SUBJECT: NRC INSPECTION REPORT NO. 70-143/2009-007

Special Inspection Team Charter
NFS Glove Box Design Issues

Report No.: 70-143/2009-007

Nuclear Fuel Services, Inc.
NRC Inspection Report 70-143/2009-007

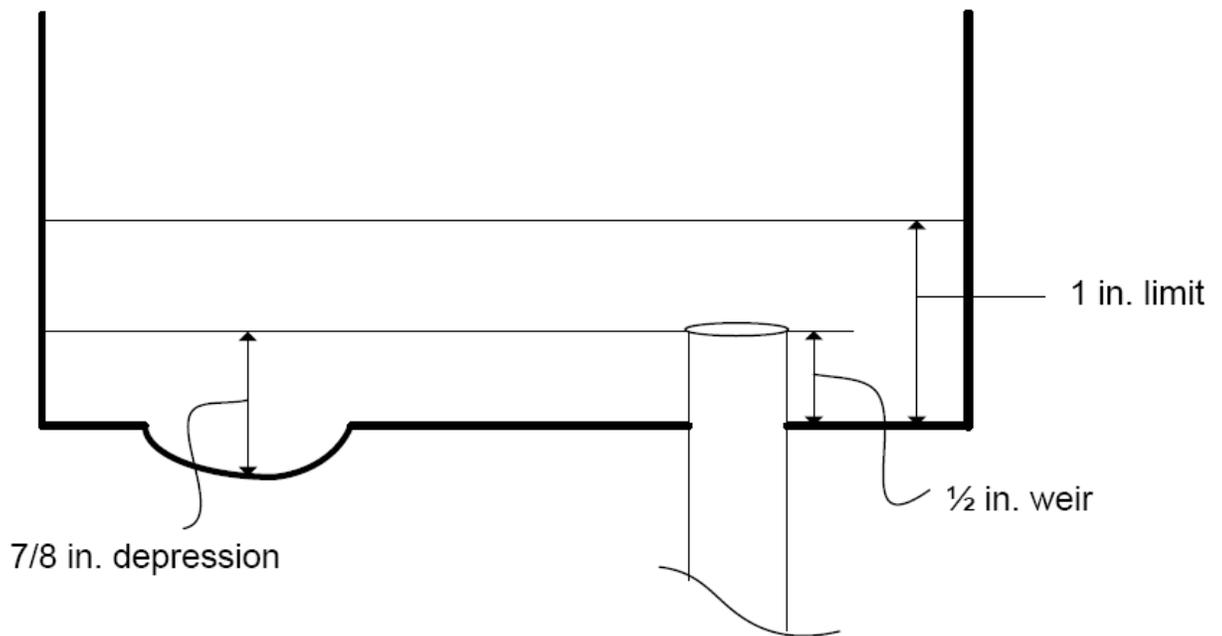
The inspectors noted that original (pre-event) calculations were based on an orifice type calculation that assumed that the glove box floor was flat and did not account for the existence of a drain weir in the glove box. During the field tests, the licensee discovered that discharge flow rates were sensitive to drain weir heights and glove box floor flatness. The licensee noted that the affected glove boxes had depressions on the floor. Furthermore, the licensee identified some glove boxes with floor depressions up to 7/8 inch measured from the top of the weir (nominally, the weir height was about 1/2 inch above the glove box floor). This condition is illustrated in the following diagram (not drawn to scale).

The inspectors determined that the solution level in several glove boxes could have exceeded the 1 inch limit in localized areas of the glove boxes where the floor was sufficiently depressed. However, the inspectors concluded that even if the 1 inch limit was exceeded in some of these localized areas the potential safety consequences would have been minimal due to safety factors used in the calculations and nuclear criticality safety analysis (NCSA). The NCSA assumed that the solution level was uniform (not localized) throughout the box, the glove box was fully reflected on all sides (i.e. the room is flooded), and that the uranium enrichment was 100%. Based on these conservative assumptions, the NCSA determined that the condition where a criticality event becomes credible occurs when the solution level exceeds about 3.5 inches. These assumptions, in addition to the drains, provide sufficient margin for safe operation of the glove boxes. The criticality safety aspects associated with the potential for exceeding the 1 inch limit will be further evaluated for significance during a future inspection by a NCS inspector and documented in a separate NRC inspection report.

The inspectors noted that the post-event calculations were based on a circular weir type calculation. The post-event calculations also used a weir height based on the lowest point (greatest depression of the glove box floor) measured in the glove box. The inspectors noted that by using the lowest point of the glove box, the calculation results would be more conservative. In addition, the licensee physically modified the weir height to ensure an adequate drainage rate. The inspectors reviewed a sample of the post-event calculations for technical completeness and accuracy. The inspectors also assessed the decision making process used for determining that glove boxes were safe to return to service. The inspectors noted that the licensee evaluated each glove box individually. The licensee performed new set point calculations for each glove box and performed an inspection of each drain. The inspectors walked down several glove boxes to independently check the weir height modifications. No findings of significance were identified with respect to the decision making process used by the licensee.
